**MONTGOMERY COUNTY PLANNING DEPARTMENT**  
THE MARYLAND-NATIONAL CAPITAL PARK AND PLANNING COMMISSION

**MEMORANDUM**

- SUBJECT:**
1. Preliminary Forest Conservation Plan: – Clarksburg Elementary School No. 8, 12615 Royal Crown Drive, Germantown, R-200 Zone, 1989 Germantown Master Plan.
  2. Mandatory Referral No. 07301-MCPS-1 – Clarksburg Elementary School No. 8, 12615 Royal Crown Drive, Germantown, R-200 Zone, 1989 Germantown Master Plan.

**SITE PLAN**  
CLARKSBURG ELEMENTARY SCHOOL NO. 8  
12601 ROYAL CROWN DRIVE, GERMANTOWN, MD 20876

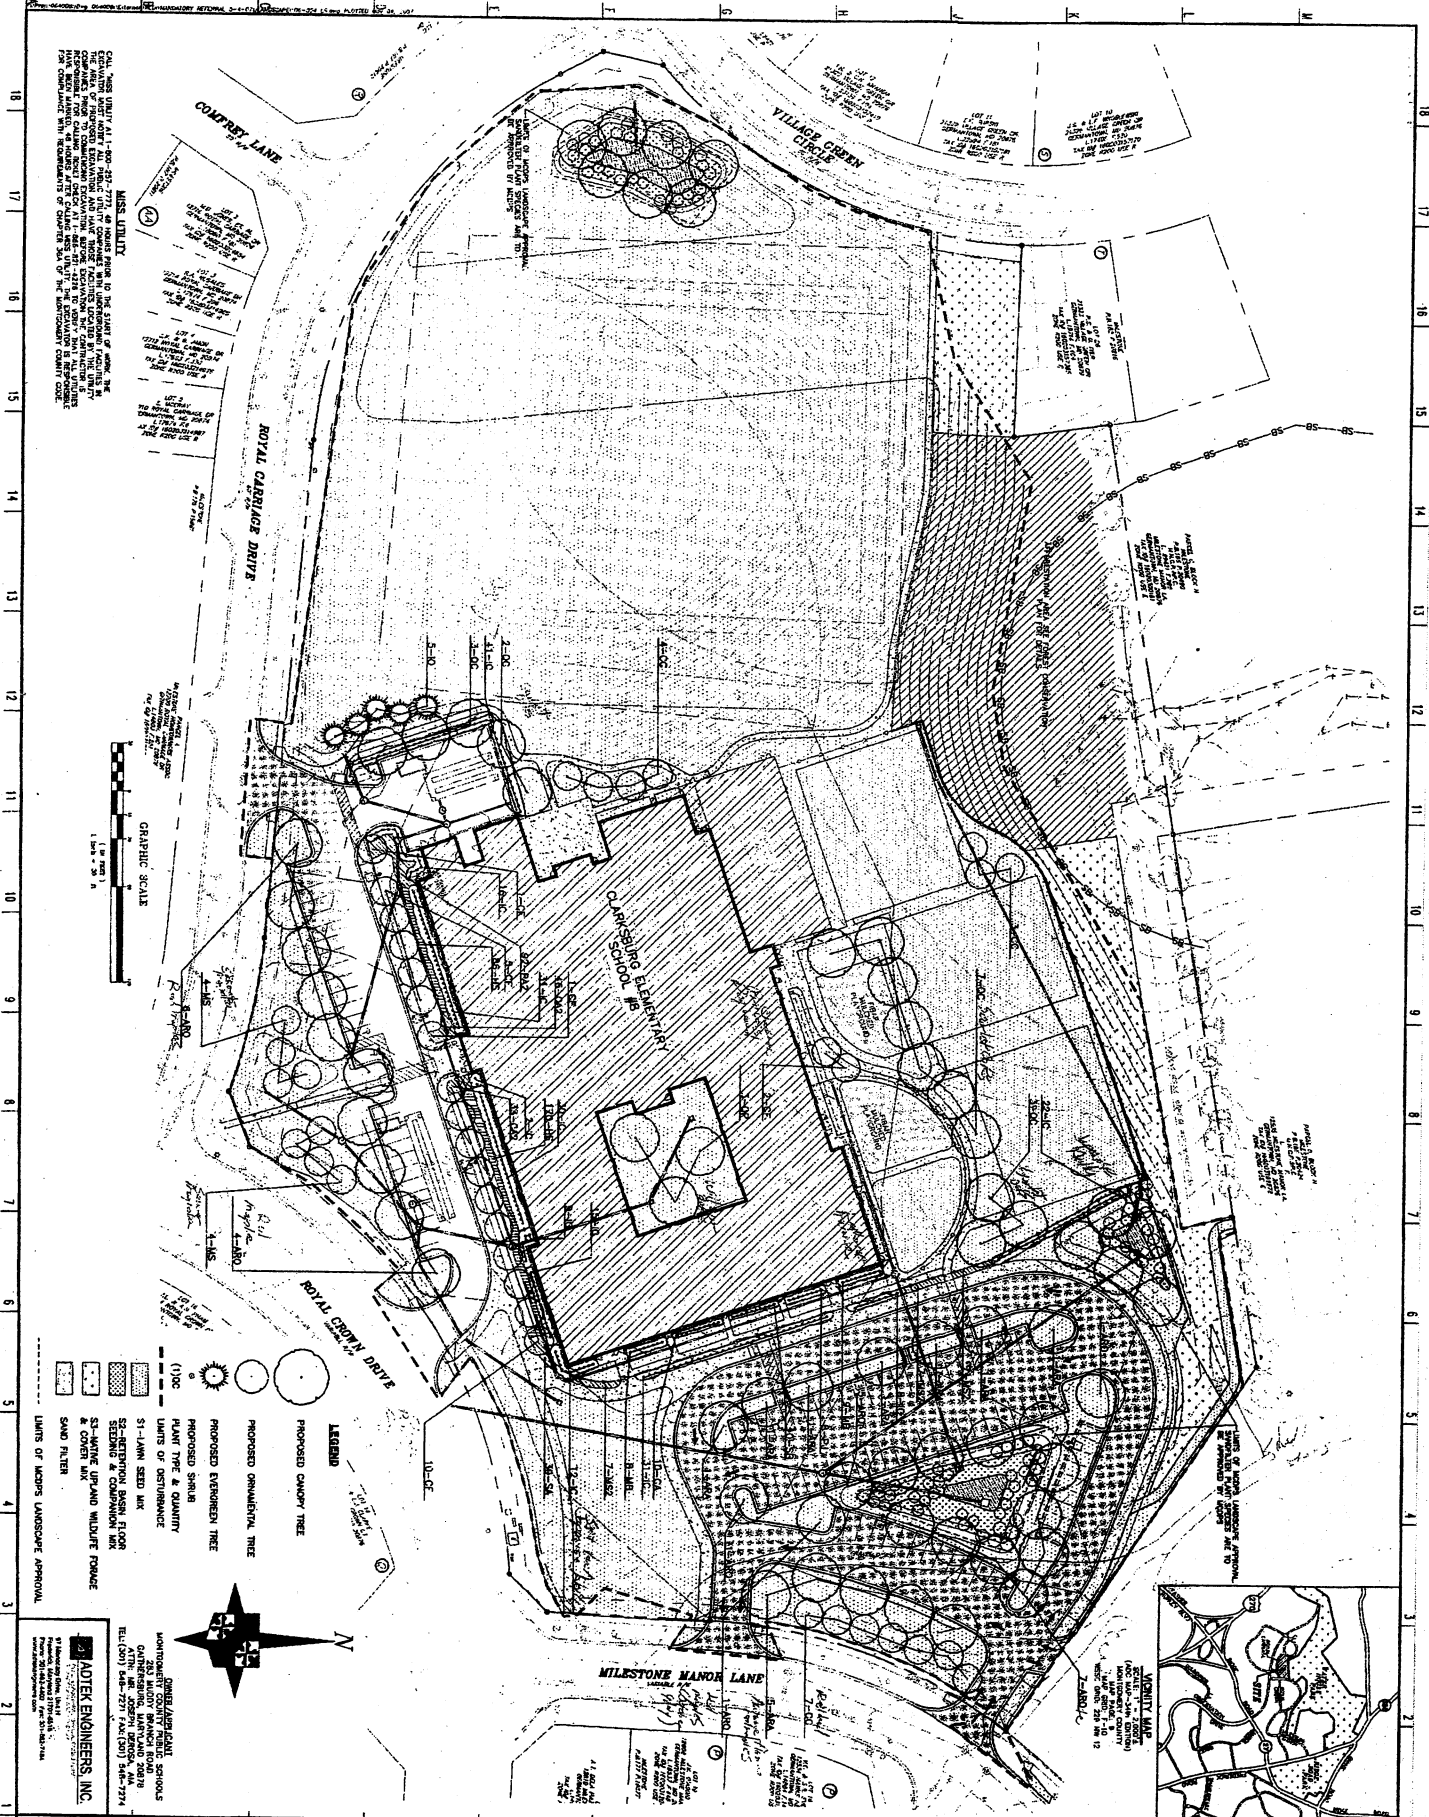
2. Plant a row of hardwood trees, spaced forty-five feet apart along the southern edge of the pedestrian path leading from the northern sidewalk of the faculty parking lot to the property line with the Waters House Special Park.
3. Coordinate and provide the following improvements to the Waters House Special Park:
  - a. Construct an eight-foot wide trail connection to the edge of the MCPS property to allow future connections by the Department of Parks;
  - b. Allow for Parks maintenance staff to enter and exit the park through MCPS property; and
  - c. Prohibit retaining walls on park property.
4. Submit a Local Area Transportation Review study if the student enrollment of the Clarksburg Elementary School No. 8 exceeds the 740 students analyzed in the traffic study for this application.

**Landscaping** – Staff believes the landscaping and lighting for the school is compatible with the surrounding community and adjacent parkland. Staff does recommend the planting of a row of shade trees, spaced forty-five feet apart, on the southern side of the pedestrian path leading from the northern sidewalk of the faculty parking lot to the property line of the Waters House Special Park, to provide shade for future users of the pedestrian and biker trail that will be developed and extended into the parkland.

**PEDSTRIAN & VEHICULAR SITE CIRCULATION PLAN**

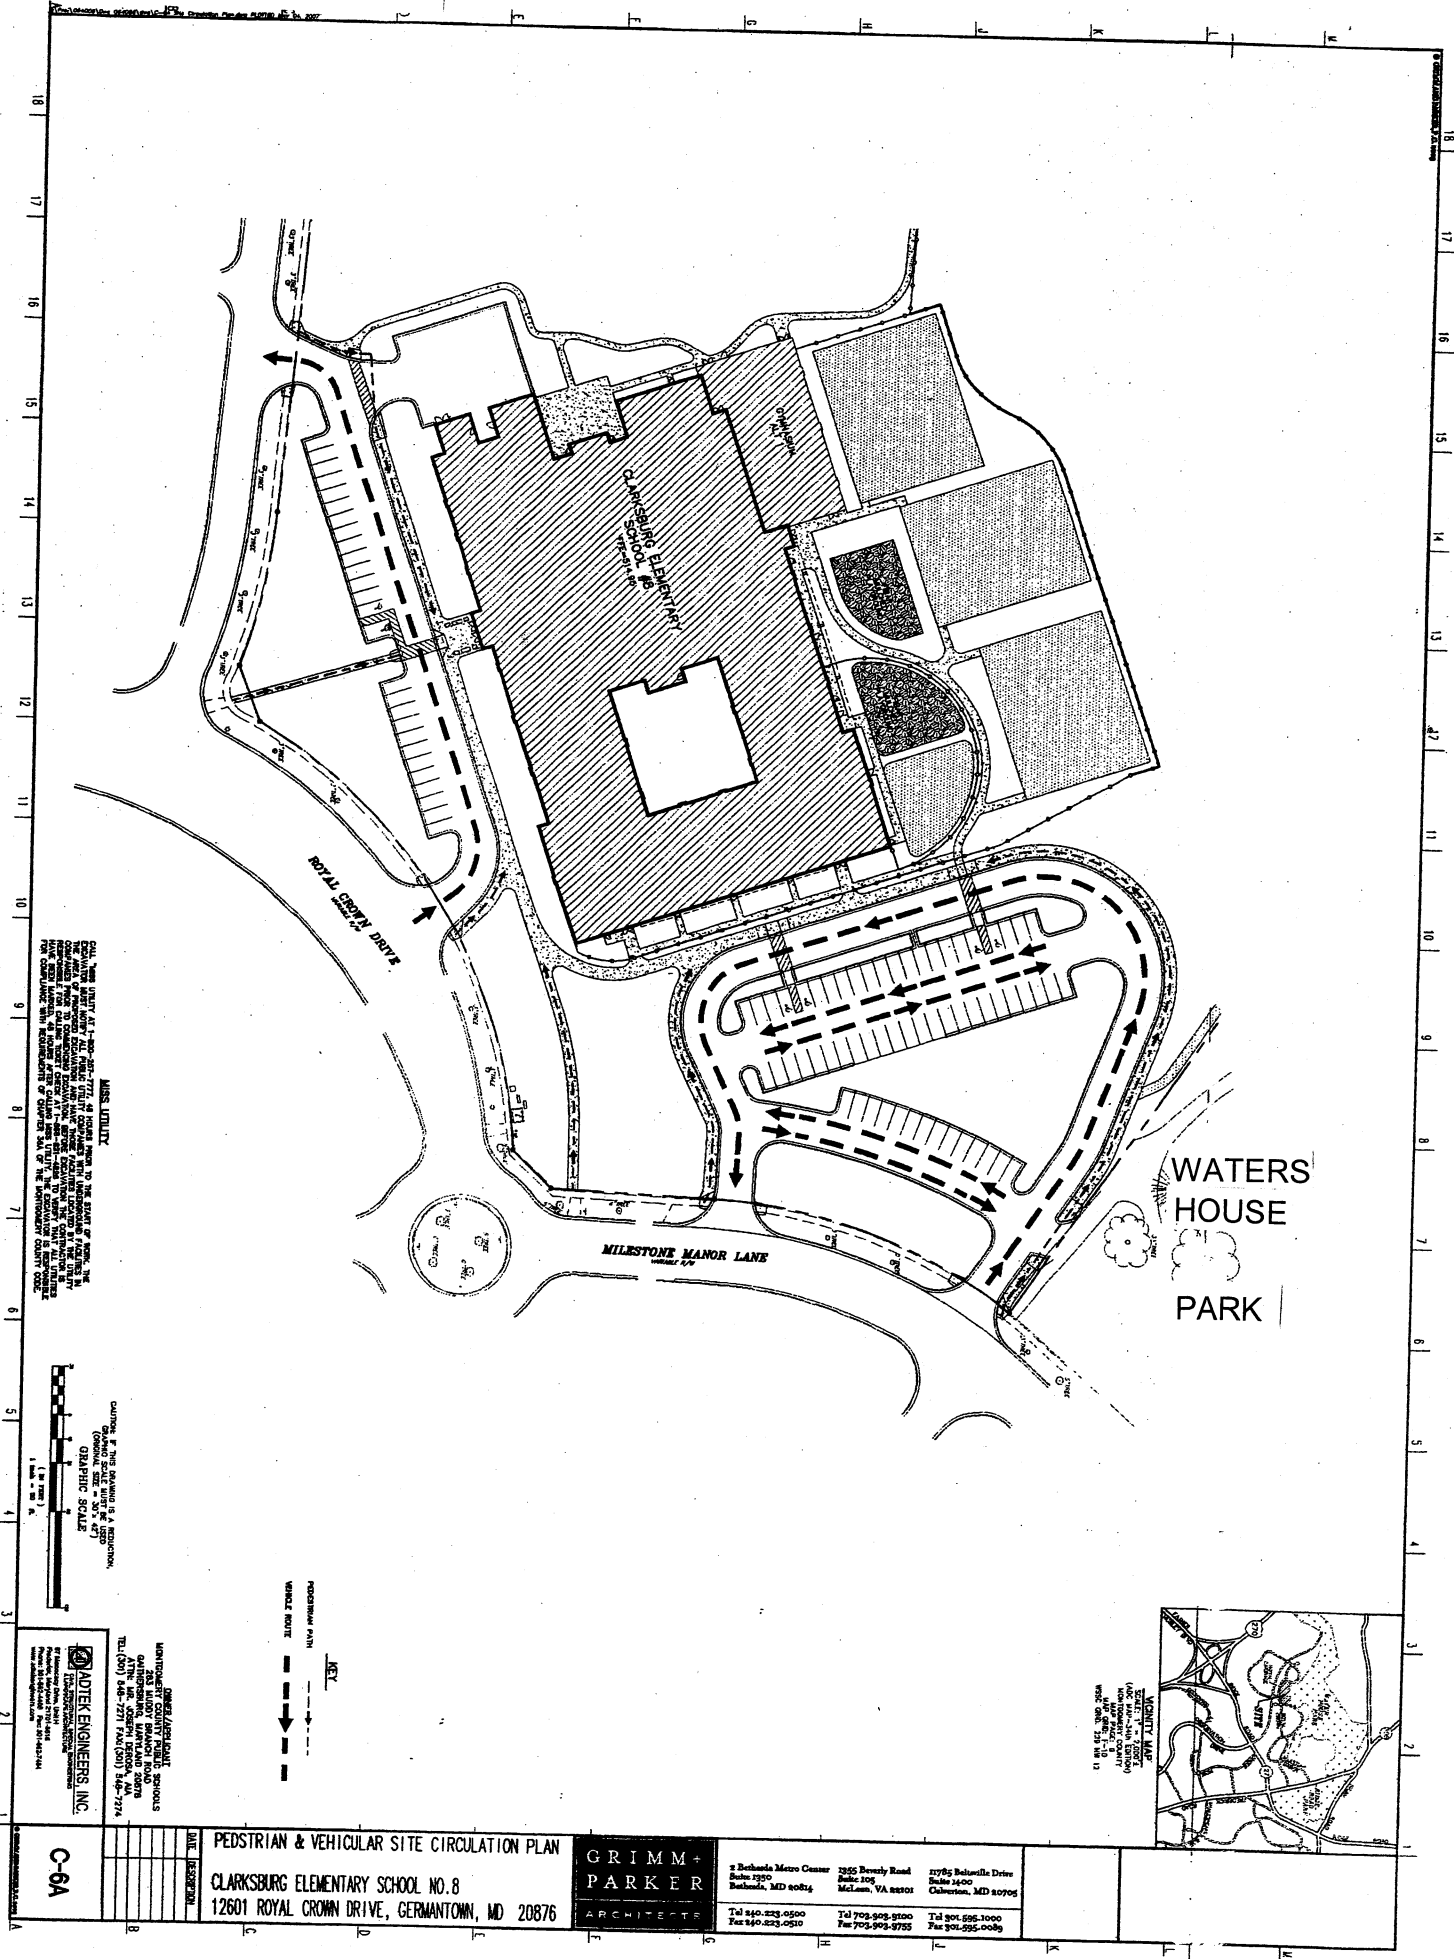
The site plan includes two separate one-way driveway loops, a bus loop and a student drop off loop. The student drop off loop consists of two driveways, one-way in and one-way out, from Milestone Manor Lane to the staff/visitor lots. The full length of the student drop off loop will be used as a stacking area during student drop-off and pick-up periods. The bus loop will be

The Montgomery County Visitor Information Center will be relocated to the Waters House site and will have access from the parking lots/student drop-off area. The directional driveways along Milestone Drive to the staff/visitor lots will provide access to both the school and the Waters House. Staff finds there will be no conflict between the school and the Waters House traffic using the same access points from Milestone Manor Lane.

Staff finds that the proposed access to the school and internal vehicular/pedestrian circulation system as shown on the site plan is adequate.

# FOREST CONSERVATION PLAN

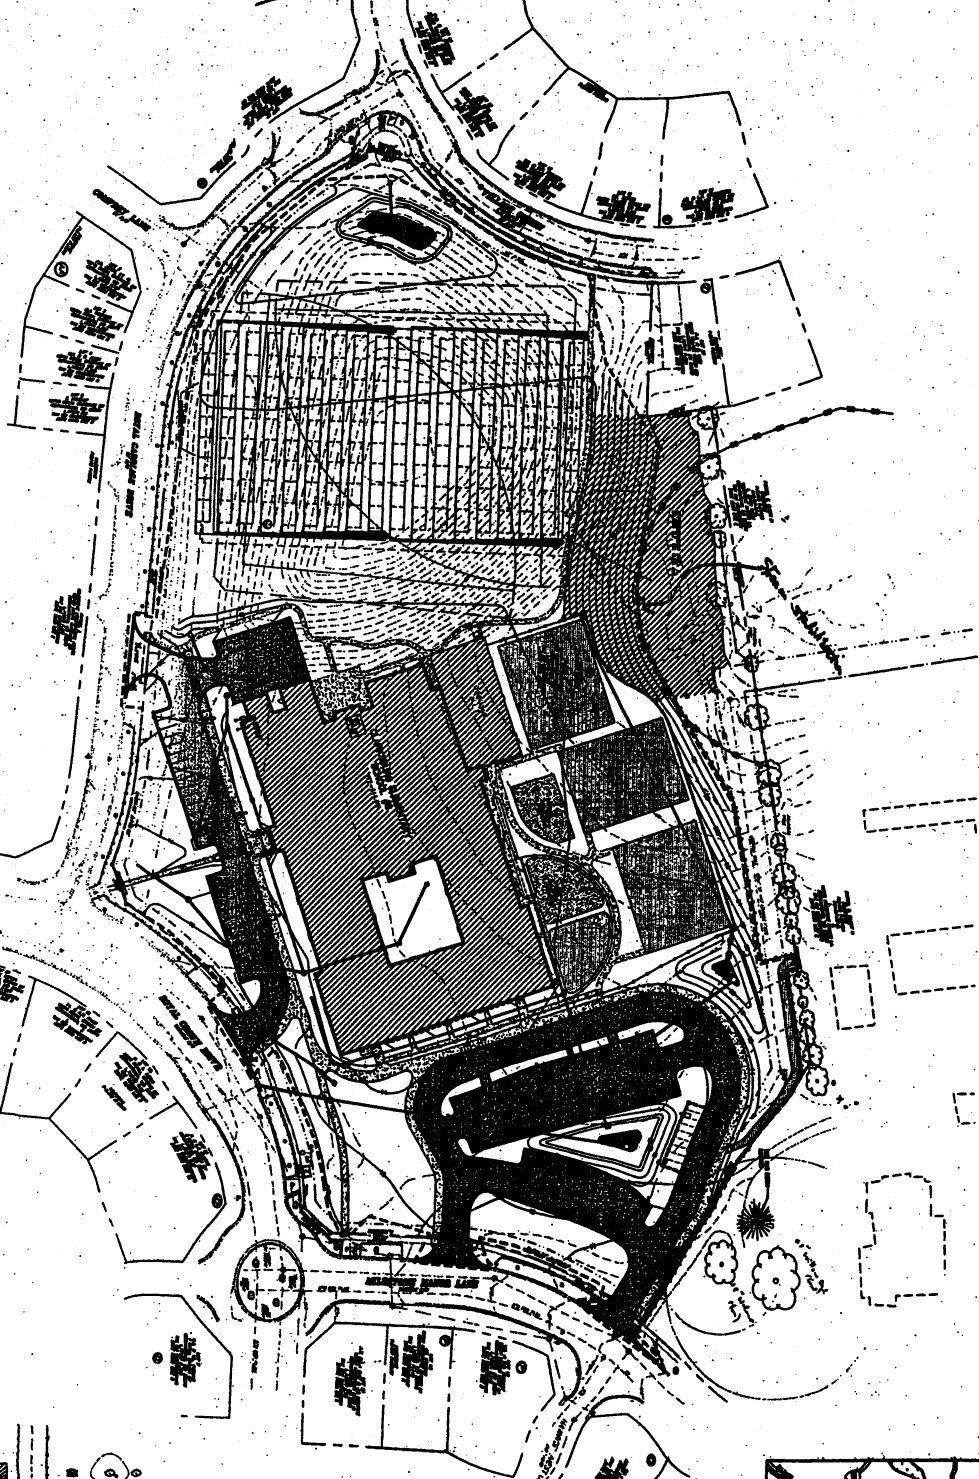
The 10.76-acre site has an approved Natural Resources Inventory/Forest Stand Delineation (NRI/FSD) (No. 4-07187) granted on March 23, 2007. Environmental Planning staff has reviewed the preliminary forest conservation plan (FCP) submitted for the project. The plan shows the site containing 0.11 acre of forest, which the applicant intends to retain. The total planting requirement is 1.50 acres. The applicant will meet this requirement by planting 0.68 acre of forest onsite and contributing 0.82 acre to a suitable forest mitigation bank. Staff recommends approval of the FCP.

1. **Approval** of the Forest Conservation Plan, with the following conditions:
  - a) Applicant to submit a Final Forest Conservation Plan that meets the requirements of Section 109(B) of the Forest Conservation Regulation. Final FCP to be approved by M-NCPPC staff prior to any clearing or grading for the new facility.
  - b) Applicant to place onsite stream buffer and afforestation areas in a Category 1 conservation easement. Easement to be protected by split-rail fencing or other measure approved by Environmental Planning.
2. **Approval** of Mandatory Referral No. 07301-MCPS-1 for Clarksburg Elementary School No. 8
